CONDITIONS OF APPROVAL:

Engineering - PUD Plan Checklist

Wood Duck Court PUD Subdivision Development Plan - Initial Submittal - 05.13.2019.pdf

10. F. Development Plan

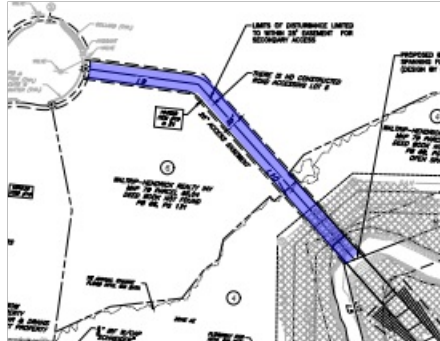
Add a roadway cross section for the access drive and new bridge. The access should be wide enough to allow for two-way traffic.

Applicant shall include a roadway typical cross-section detail for the access drive, indicating pavement width and how roadway drainage is accounted for. (Cross-slope of the drive, type of curb, if gutter or ditch sections are to be used.)

Applicant shall add a label specifying the cross-section is applicable only to the access drive. Applicant shall add note below cross-section: "Preliminary design only, curb and pavement details to be finalized at the site plan stage."

A typical roadway cross section has been added to sheet C4.0.

71. H. Stormwater Management Plan

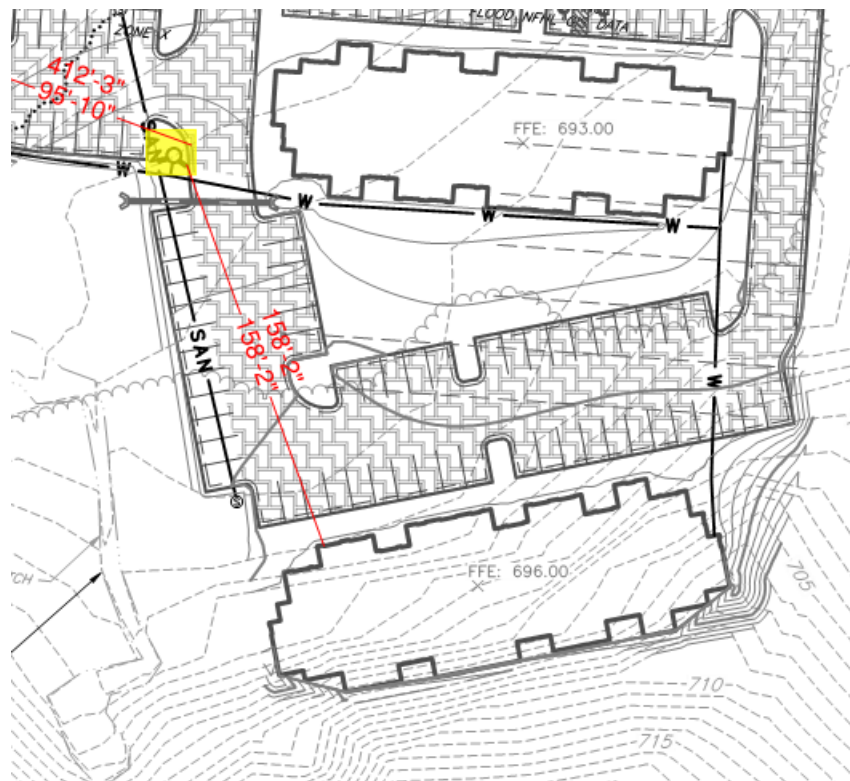
The submitted Development Plan proposes to utilize stormwater treatment practices which are not outlined in the City's BMP Manual and for which site-specific design information is not available at this time. At Site Plan, the applicant shall coordinate with COF Engineering and Stormwater staff to provide acceptable equivalent measures for stormwater treatment to the standard treatment practices outlined in the BMP Manual, including detailed design information and proposed equivalencies for stormwater treatment credit. While not anticipated to be necessary, any disagreement between the development design team and the City Engineer regarding proposed equivalent measures which cannot be resolved at staff level shall be submitted as a variance for approval by the Stormwater Appeals Board.

42. Water

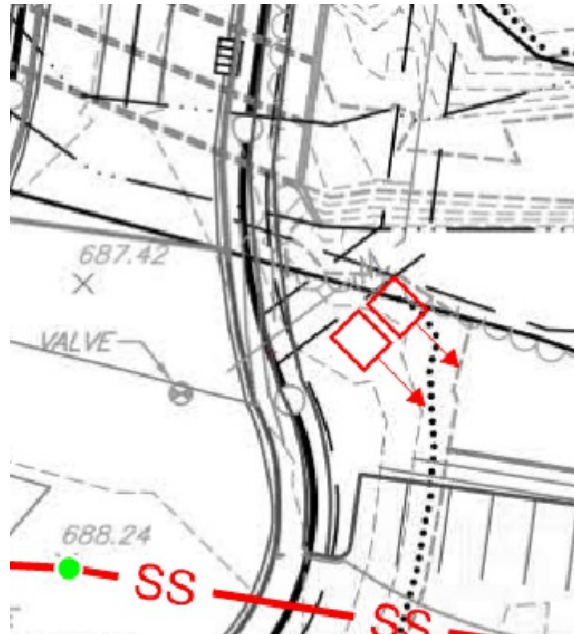
The applicant shall show the water and fire meter lines at the property line. From there the internal water lines to the site shall be designed as private. The water lines shall be designed to be out from under structures, trees, etc.

The applicant has adjusted the meter areas for water and fire service. At site plan, the meter location will be looked at critically and at that time the final placement will be determined.

The proposed meter locations have been added to sheet C5.0. The meter boxes were placed such that there is minimal crossing of permeable pavement to serve the site.
